Date: 15 Oct 89
To: X3T9.2 SCSI Committee Members
From: Kurt Chan, Gordon Matheson
Subject: Alt2 Termination: Worst-Case Analysis and Recommendations

X3T9.2/89-115R1

FIG 1

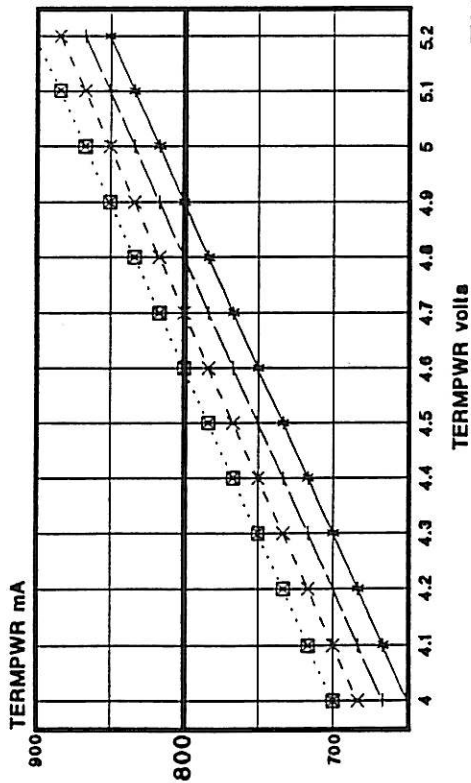
Figure 1 depicts the relationship between I(termpwr), V(termpwr), and V(ol_avg) on SCSI-1 systems (Alternative 1 termination). In order to stay below the 800mA SCSI-1 limit under all V(ol) conditions, V(termpwr) must be around 4.6V or less. Since TERMPWR typically comes from a 4.75-5.25V supply and is diode-protected, it is generally a safe bet that V(termpwr) averages 4.6V or below at both ends of the cable, and explains why 800 mA is not exceeded in most SCSI-1 systems.

FIG 2

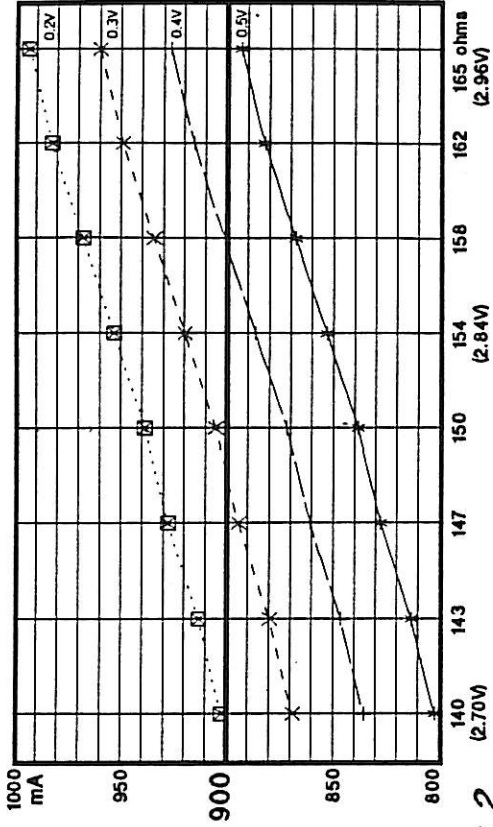
Figure 2 shows the relationship between I(termpwr), R2, and V(ol_avg) on SCSI-2 systems with the Alt2 terminator (R1=120, Rpullup=110). In order to stay below the SCSI-2 900 mA limit for all V(ol) conditions, R2 must be lowered to 140 ohms, resulting in a reduction of V(out) from 2.84V nominal to 2.70V nominal.

The Rev10b value of R2=154 ohms is acceptable only assuming the average V(ol) for all 16 signals is 0.35V.

FIG 3

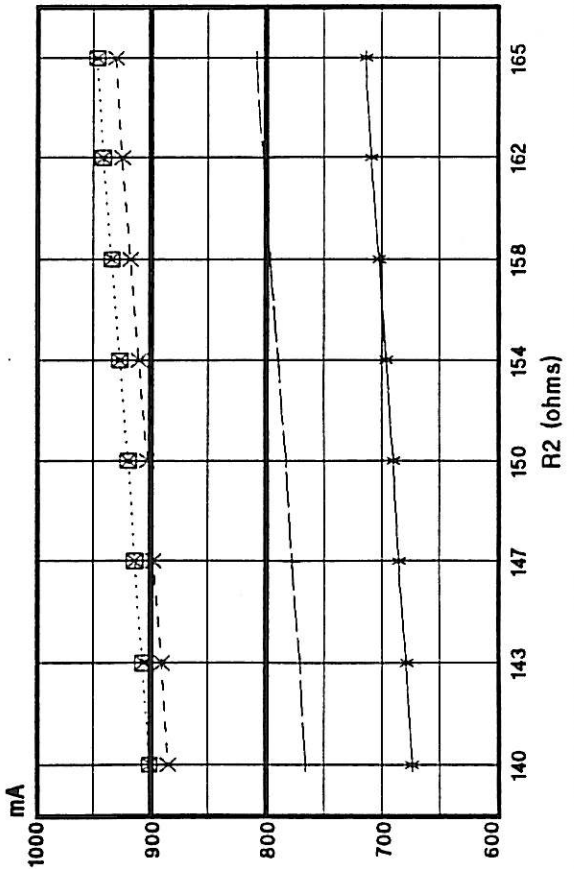
Figure 3 shows I(termpwr) for systems which have Alt2 termination on one end and Alt1 termination on the other. The four cases are:

"Low": V(ol)=0.50V, V(termpwr)=4.00V, V(alt2)=lowest
"Typ": V(ol)=0.35V, V(termpwr)=4.30V, V(alt2)=nominal
"Hi1": V(ol)=0.20V, V(termpwr)=5.00V, V(alt2)=highest
"Hi2": V(ol)=0.20V, V(termpwr)=5.25V, V(alt2)=highest

Assuming worst-case conditions, there are no viable values for R2 which will ensure I(termpwr)<800 mA. Assuming TYPICAL values, R2=154 is acceptable.

FIG 4

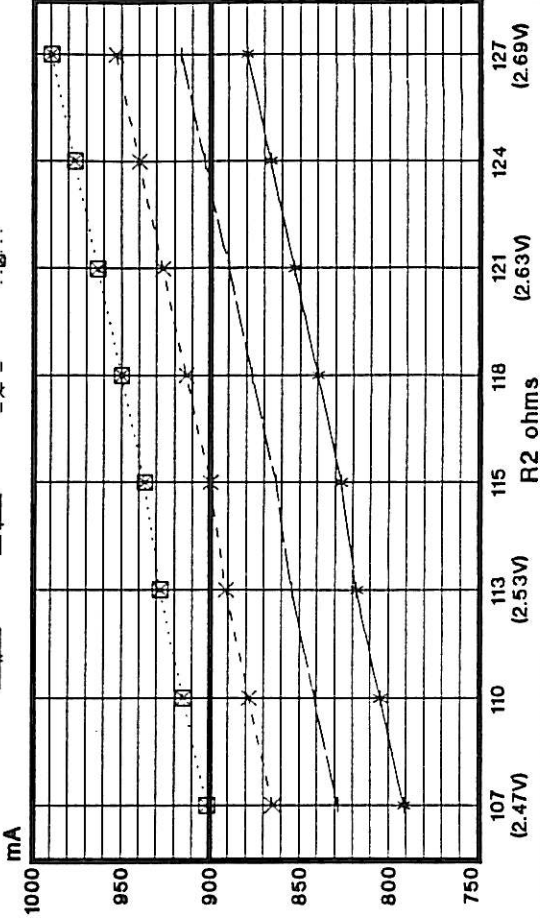
Figure 4 shows TERMPWR current for the 100-ohm version of the Alt 2 terminator (Rev 10B, Figure 4-9, note 2). Note that the Rev 10b value will only keep I(termpwr) under 900 mA under typical conditions. Worst-case design would require R2=107, which would yield an unacceptably low termination voltage.
